January 13, 2022

Dear Newton Historical Commissioners,

We are writing to express our desire to see the Newton Historical Commission (NHC) do everything in its power to ensure that the decision to Landmark 145 Warren is not in vain. What tilted the scale in favor of the Special Permit was the promise of building to "passive house" standards and the development be LEED certified. But there is a tension between building to those standards and the Landmark preservation standards. We believe it is a slippery slope if Newton starts weakening its preservation standards for Landmarks, which is supposed to be the highest level of protection, in favor of other goals which are not codified in ordinances.

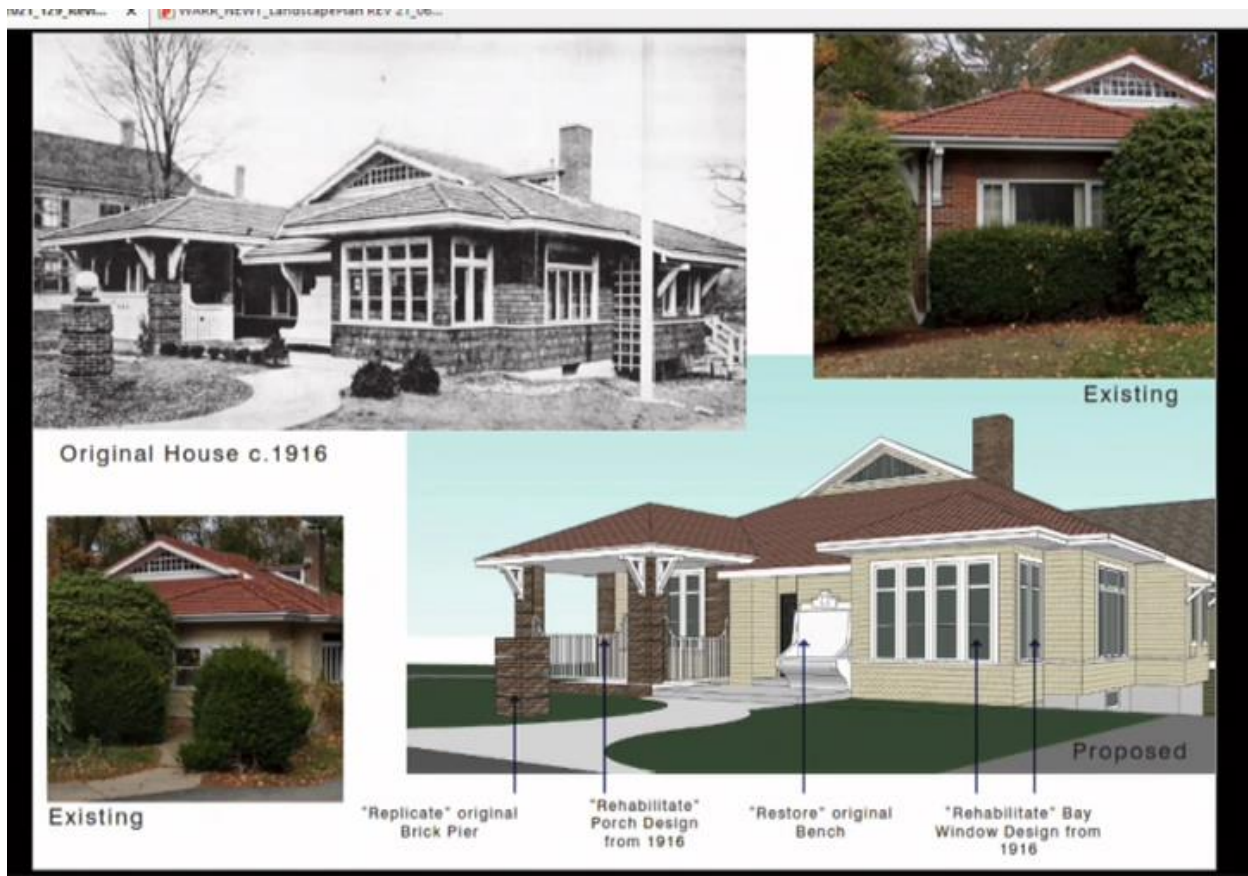
2. In regards to claim that the development not being visible from the street, that is absurd. . Below is the view from the driveway of 136 Warren. If the Landmark is at 12:00, this is the view from 5:00. Clearly the structure will be visible from the street. Only if the viewer is standing directly in front of the Landmark structure would the development behind it not be visible. Take a few steps and the new additions will be clearly and obviously visible

Siding

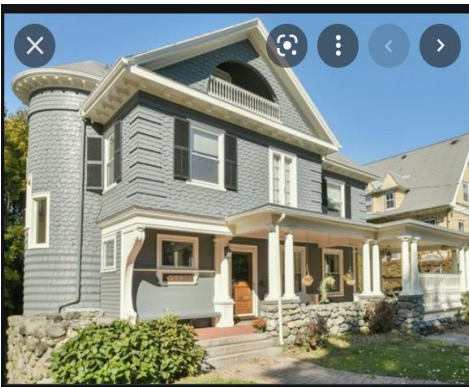
There was a comment made in the November HC meeting that the developer intended to restore the siding to its natural color which was described as stained cedar siding, but then they also talked about paint colors. In the board order crafted by the Planning Department it was stipulated that they would scrape and paint, but that is just routine maintenance, not historic restoration. We feel that the siding should be restored to the original color/stain to be most authentic to the original house. It is also noteworthy that in the proposed picture above, the siding is shown to all be of a consistent size, running horizontally. But in the original picture, there is clearly a pattern change between the bottom third and the top two thirds so if they are keeping the siding, that doesn't make sense. You will note that in the picture below of 31 Chase, also built by William Church, there is similar execution of a pattern change with the shingle siding. We think that is a significant element.

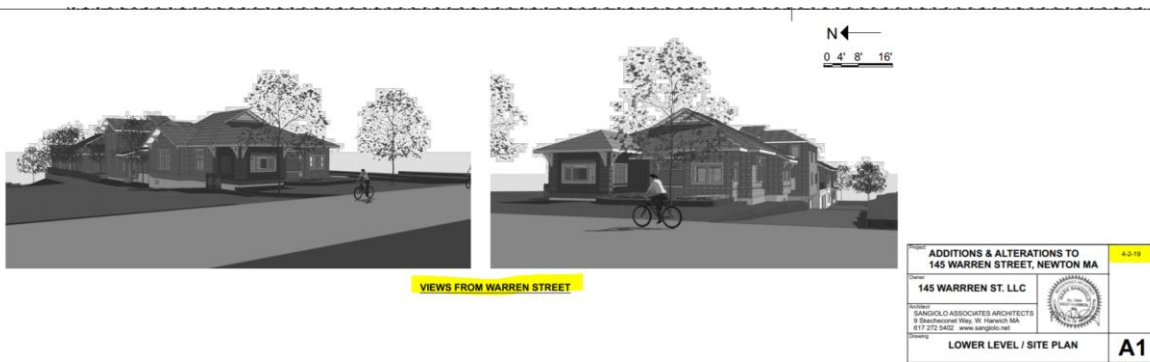
A relevant data point from the developer's depiction below is how the view from Warren Street was represented. Clearly the development is visible from the street. While that might be okay when making a decision related to a partial demo permit, we understand that Landmark standards are higher. None of the changes from the 1st developer's plans and CIVCO's design approved through the Special Permit change that street view that is not our representation but the developers.

The relevant data point below is that when the 1st developer was presenting plans for a waiver of a demo delay, when the property was not yet a landmark, they were committing to carrying both the tile roof (synthetic) and shingle siding through the addition. This creates the congruity that the neighbors requested in our 1/13/2022 email to the NHC. A lower treatment should not be acceptable since this is now a Landmark.

The one difference is that the area marked out in red has been eliminated, however the lower level still creates an uninterrupted connection between the original house and the rest of the structure and that elimination will not change the street view. Also we believe that the roof line of the back half of the structure is now more solid vs the multi-height showed in the drawing.
